Product Change Notification: DSNO-24JSZR057

CCB 7231.010 Final Notice: Qualification of MMT as a new final test site for selected AT27C512R-70PU, AT28C256-15PU, AT28C64B-15PU, AT27C256R-45PU, AT27C256R-70PU and AT27C512R-45PU catalog part numbers (CPN) available in 28L PDIP (.600in) package.

CCB 7231.010
Pre and Post Change Summary
PCN #: DSNO-24JSZR057

Pre and Post Change Summary - TUBE

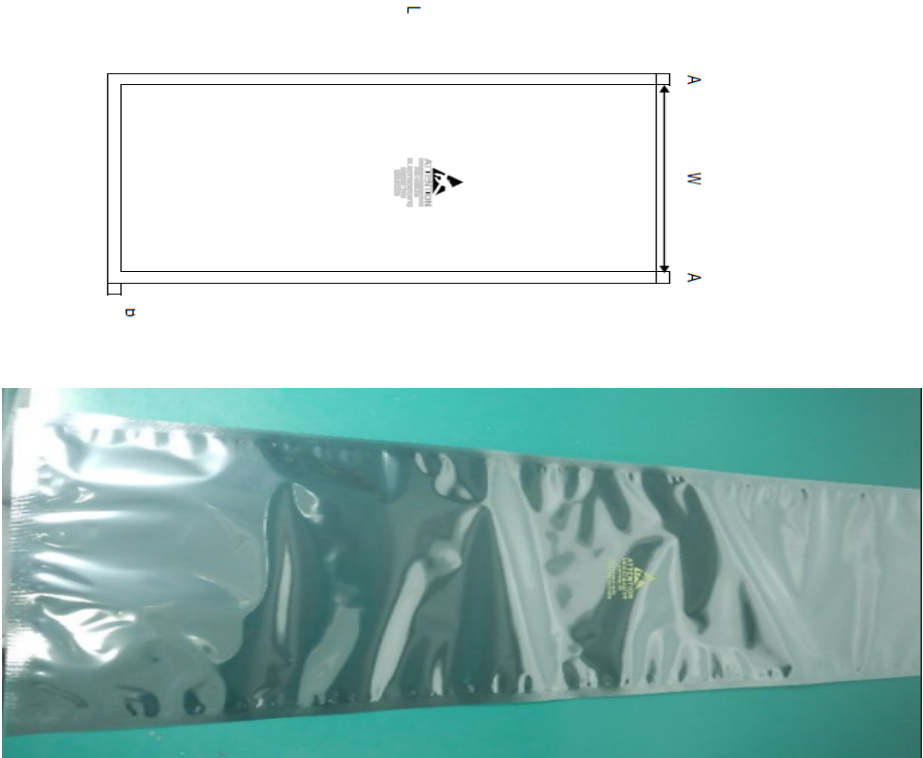
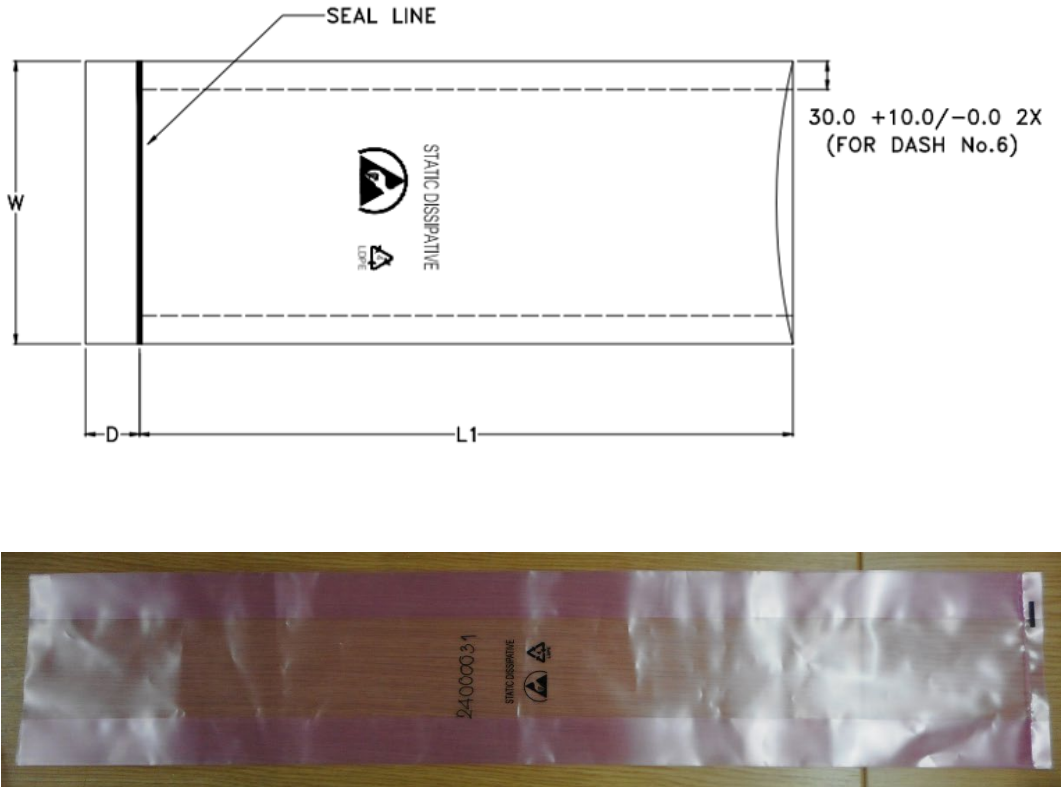
Location	Tube Length (inch)	Dimension	Hole Usage	Tube Length between Hole Usage	Unit per Tube	Tube per Bag	Tube Color
MPHL	23.75 +/- 0.05	See on drawing	Hole B to Hole E	20.76 +/- 0.03	10	24	Transparent Clear
MMT	23.75 +/- 0.05	See on drawing	Hole B to Hole E	20.76 +/- 0.03	10	24	Transparent Clear
